ADDENDUM NUMBER: ONE

**ISSUED BY: SEPW Architecture Inc.
206 – 1275 Broad Street, Regina, SK S4R 1Y2
PH. (306) 569-2255**

**PROJECT: ESDC – PPT REGINA AMALGAMATION
REGINA, SK**

Project No./No. du projet R.060346	Sheet/Fauille A3.1R1 OF 23	Revision no./ Loi Révision 1
--	---	---

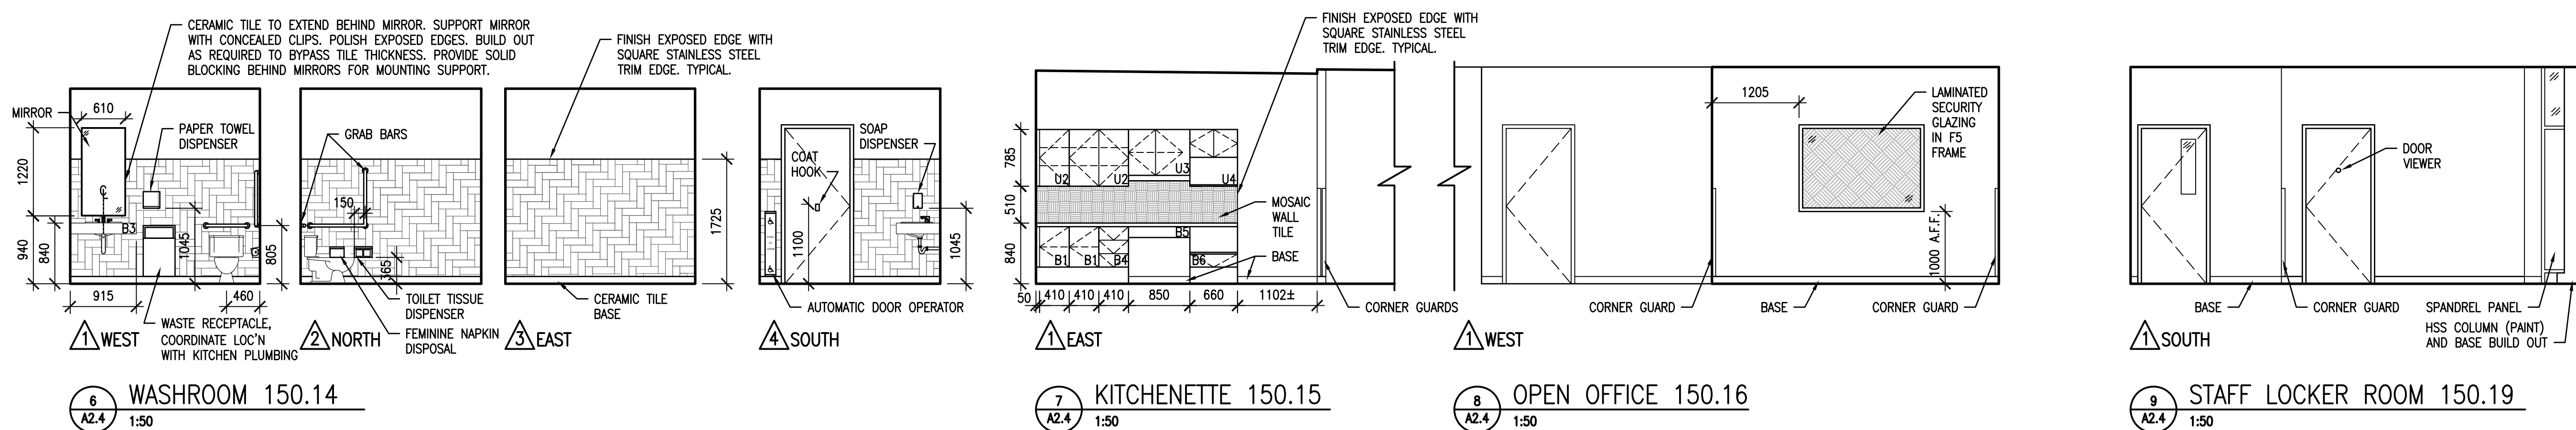
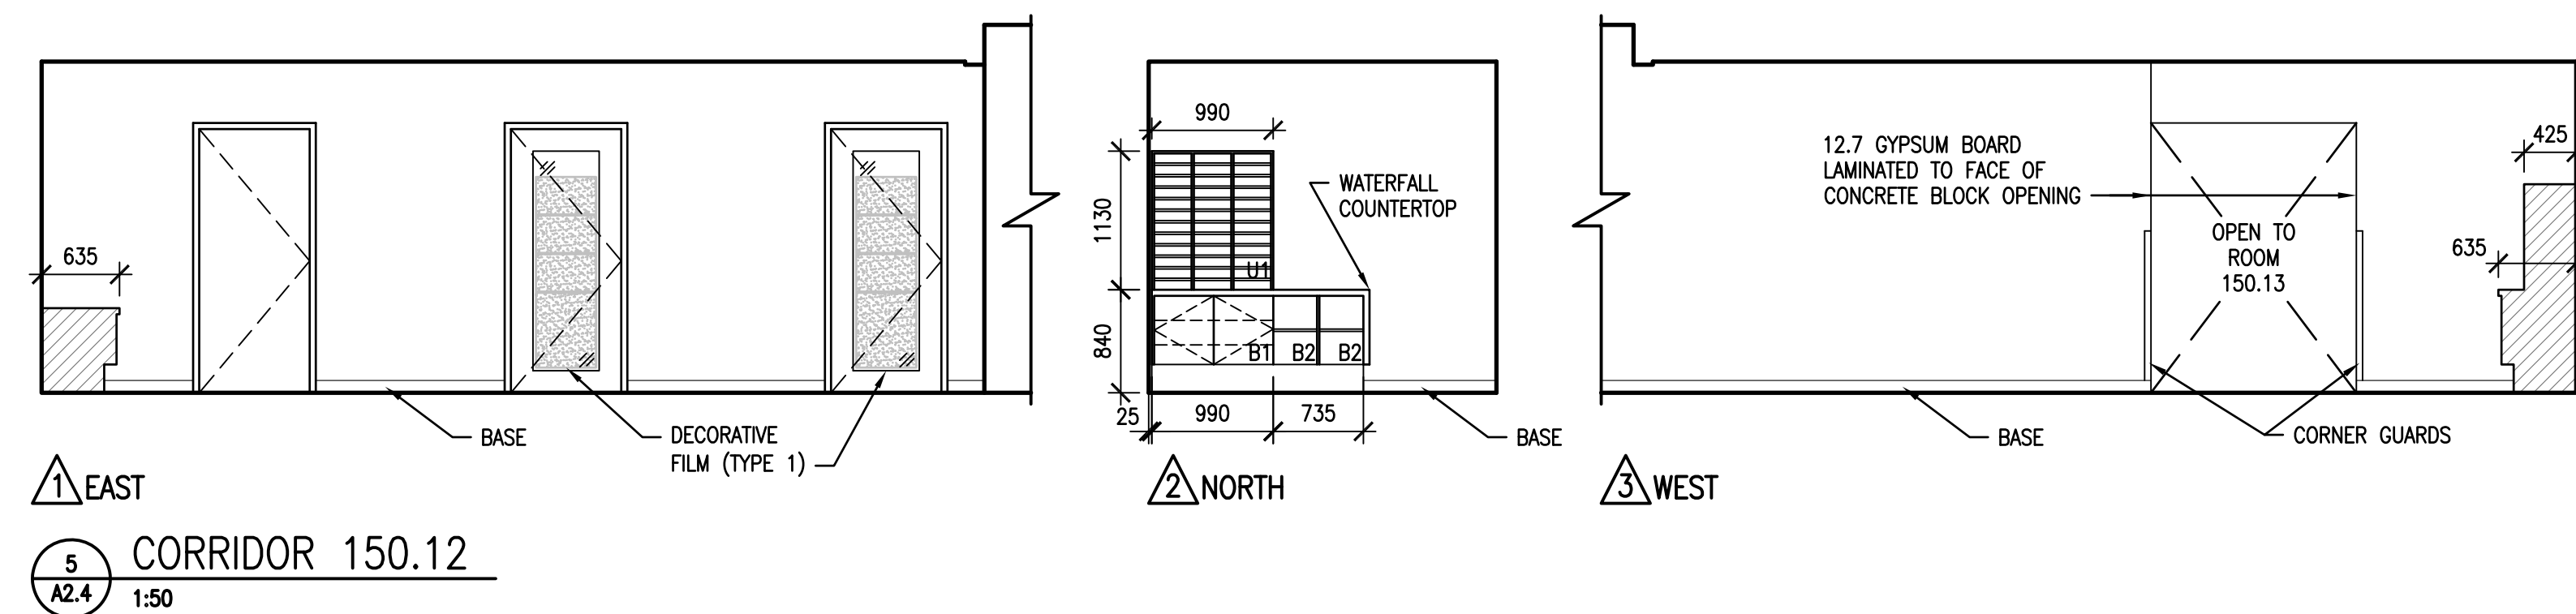
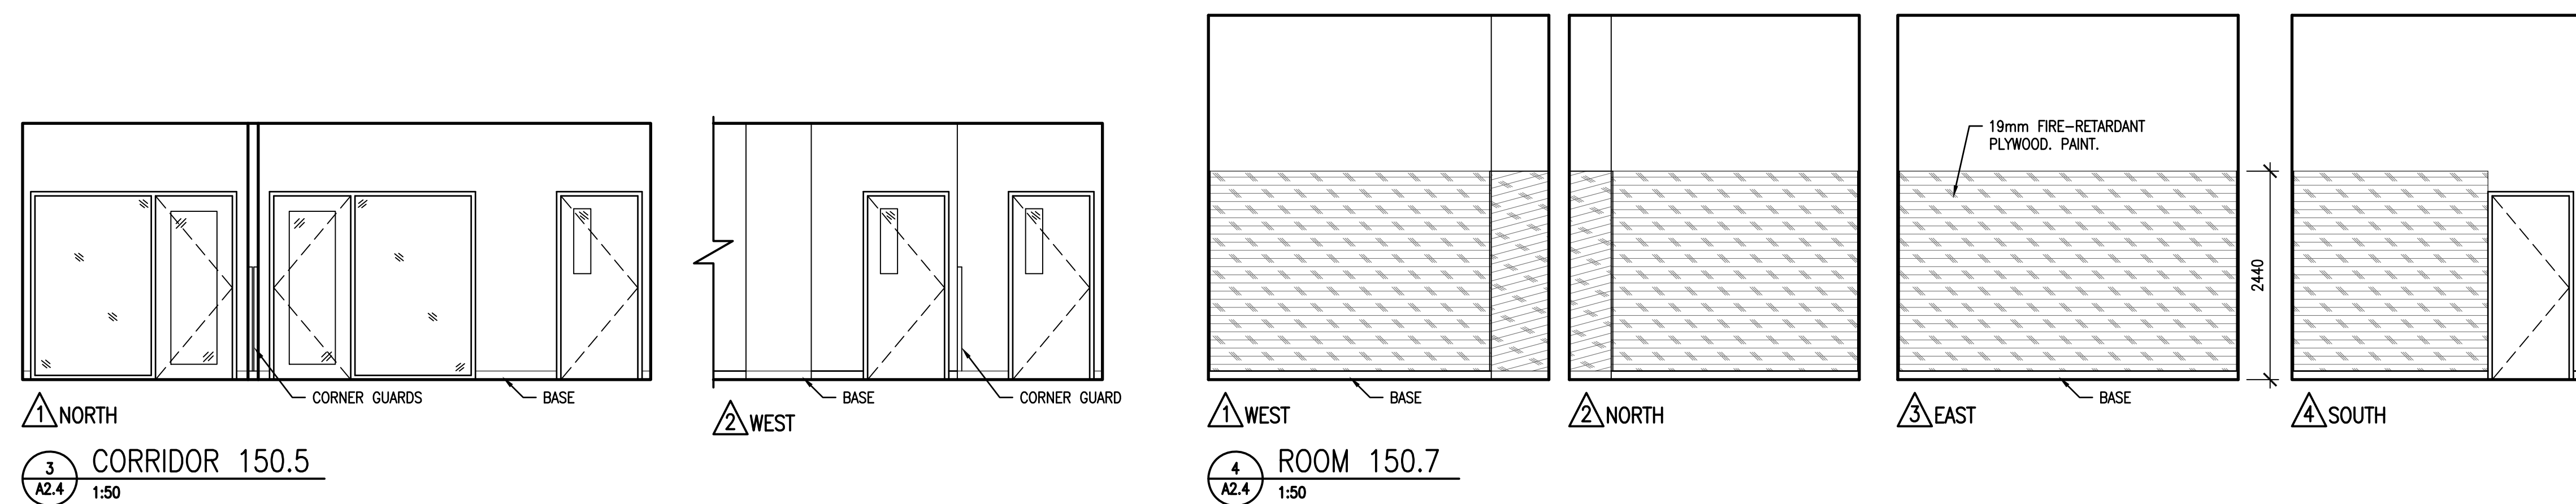
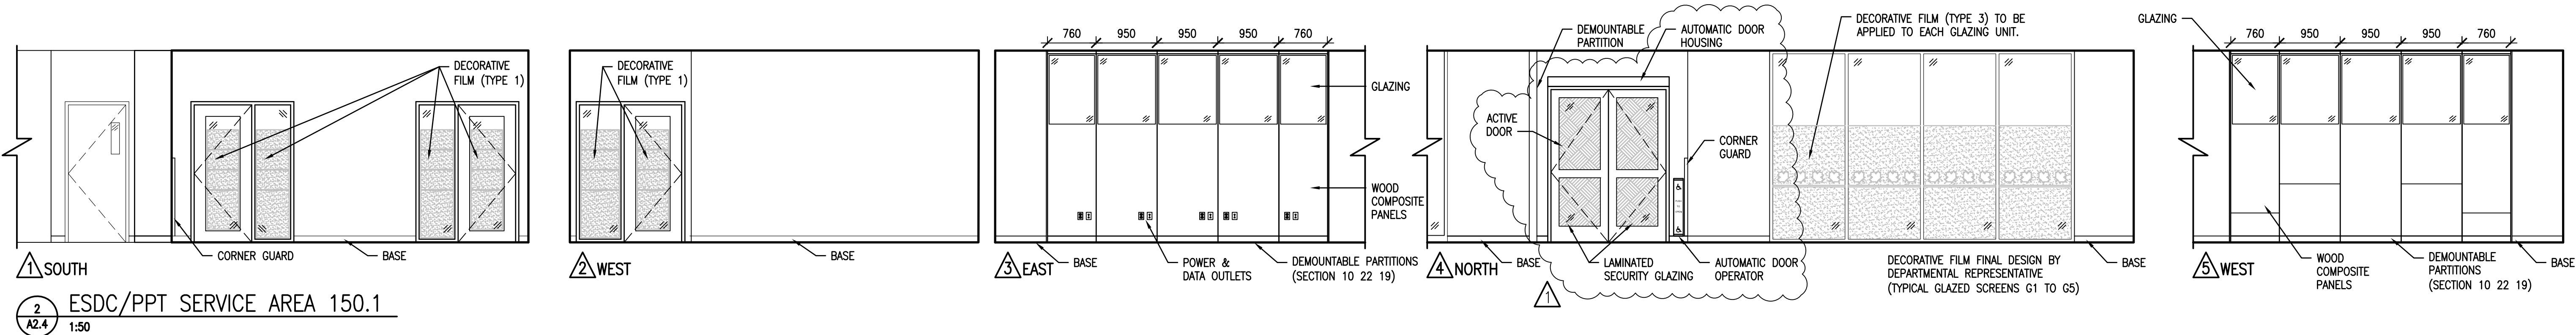
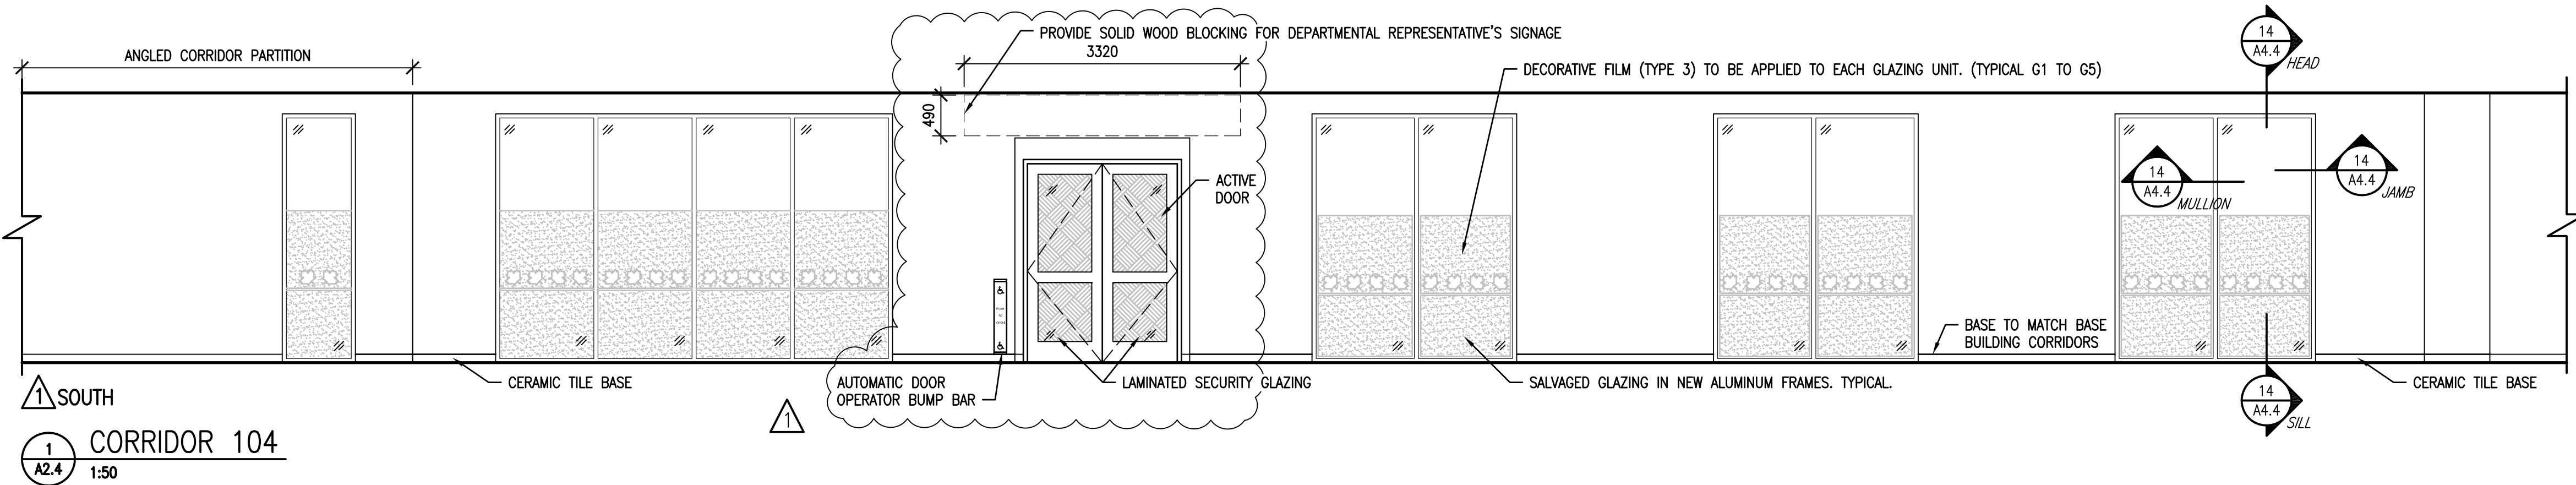
- .1 REPLACE this drawing in its entirety with Drawing A3.1R1 accompanying this addendum.
- .2 Reference Detail 1, Corridor 104 Interior Elevation; CLARIFICATION, refer to drawing A3.1R1 accompanying this addendum for location of automatic door operator bump bar in Corridor 104 and the designated active door.
